HEARING DATE: May 18, 2023

TO: Planning & Zoning Commission

SUBJECT: Ringneck Place Subdivision AZ, PP  
H-2023-0009

Annexation of 1.73 acres of land with an R-8 zoning district, Preliminary Plat consisting of 9 residential building lots and two (2) common lots on 1.539 acres for Ringneck Place Subdivision.

B. Preliminary Plat (dated: 1/30/2023)

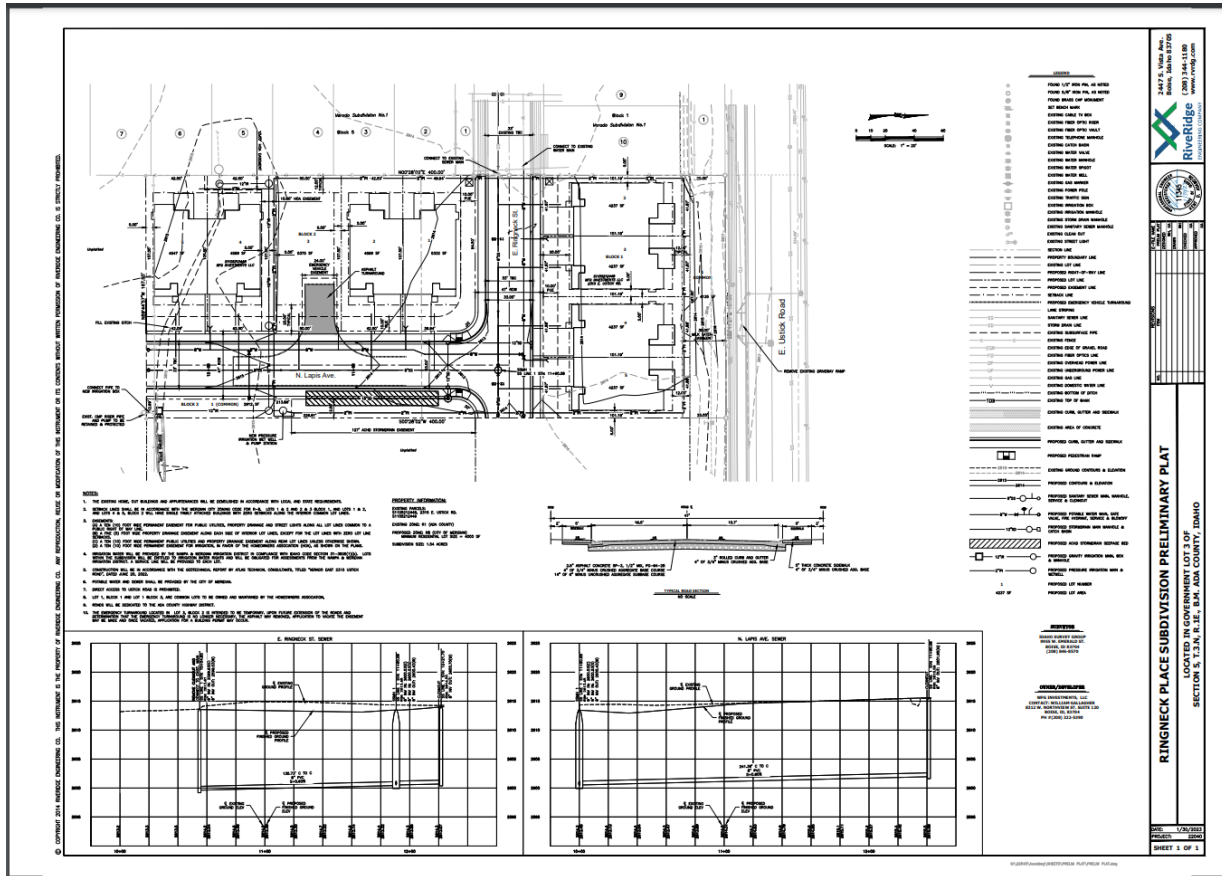
**Access:** Access is proposed from E. Ringneck Street from N. Verado Ave. and E. Ustick Road. Direct lot access from E. Ustick Road is prohibited. 3A. **The Applicant is proposing to remove the existing**

*curb cut to E. Ustick Road on this site as depicted on the preliminary plat. An Emergency Vehicle Turnaround is depicted on the plat over Lot 3, Block 2; the intent is to remove the turnaround to accommodate a single-family residential home once N. Lapis Road is extended in the future. The Applicant has proposed to landscape this parcel to be used as common open space for the development until such time that N. Lapis Road is extended.*

2. The final plat shall include the following revisions:
  - a. Include a plat note that restricts Lot 3, Block 2 from being a buildable lot until N. Lapis Road is extended in the future.

- b. Graphically depict zero lots line on the plat for those lots that will be developed with single-family attached homes.
3. The landscape plan submitted with the final plat shall include the following revisions:

- 1.1 Call out removal of blow-off valve on water main along west boundary of site.
- 1.2 Dead ends to the east and south need to either end in a fire hydrant or a 4" blow-off.
- 1.3 Ensure no sewer services pass through infiltration trenches.

C. Landscape Plan (dated: 1/26/23)

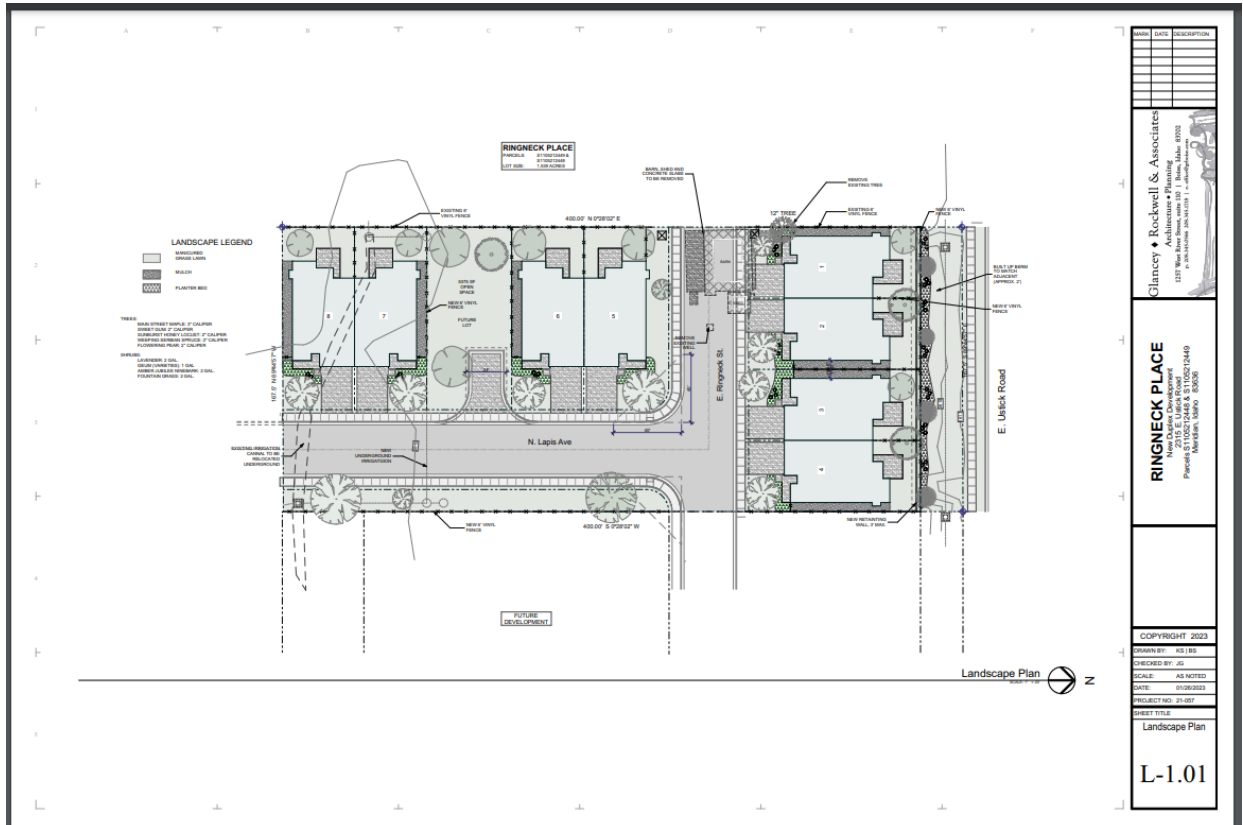
**Landscaping** (UDC [11-3B](#)): A twenty-five-foot landscape buffer is required along E. Ustick Road in accord with UDC 11-3B-7. The landscape plan submitted depicts a thirty-foot landscape buffer along E. Ustick Road due to the Milk Lateral Easement. *Staff finds that the landscape plan should depict less lawn and a wider planter bed with an additional mix of a variety of shrubs, mulch, and other vegetative ground cover in accord with UDC 11-3B-7C.*

**Fencing** (UDC [11-3A-6](#), [11-3A-7](#)): All fencing is required to comply with the standards listed in UDC 11-3A-7. *According to the submitted landscape plan, the Applicant is proposing 6-foot Vinyl fencing around the perimeter of the site and between the single-family attached homes. A detail of the fencing should be provided with the final plat.*

- a. Replace the gravel area in the parkway area with vegetation in accord with UDC 11-3B-7C and remove the driveway and replace it with curb, gutter, and sidewalk per ACHD standards

- b. Depict a fencing detail for all new fencing proposed for the subject site.
  - c. Lot 3, Block 2 shall be landscaped and used as common open space for the development until such time that N. Lapis Road is extended.

- d. Revise the landscape plan to depict less lawn and a wider planter bed with an additional mix of a variety of shrubs, mulch, and other vegetative ground cover in accord with UDC 11-3B-7C within the 25-foot landscape buffer along E. Ustick Road.
